From: Kristen Kapelanski, AICP
 Date: 6/4/2019
 Re: **Level One Bank (City File #19-015)**
Site Plan - Planning Review #1

From: Mark Artinian, R.A., Building Inspector/Plan Reviewer
To: Kristen Kapelanski, Planning Department
Date: May 28, 2019
Re: Level One Bank
1880 S Rochester Rd
Sidwell: 15-22-451-030
City File: 19-015

From: Jason Boughton AC, Engineering Utilities Specialist
To: Kristen Kapelanski, AICP, Manager of Planning
Date: May 6th, 2019
Re: Level One Bank, City File #19-015, Section #22
Site Plan Review #1

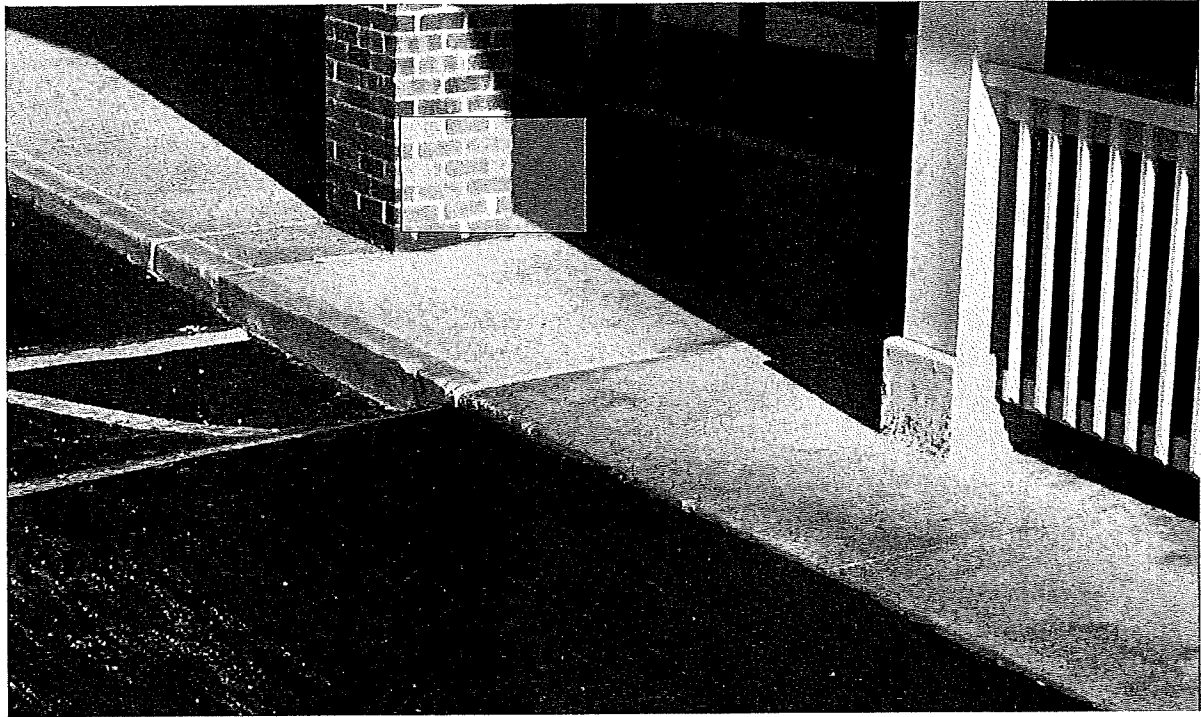
The proposed accessible path is unsafe due to the narrow passageway from the parking lot to the sidewalk and the close proximity to the sloped asphalt at the existing route. Refer to the attached photo. Use the existing accessible route and provide the curb cut as noted above.
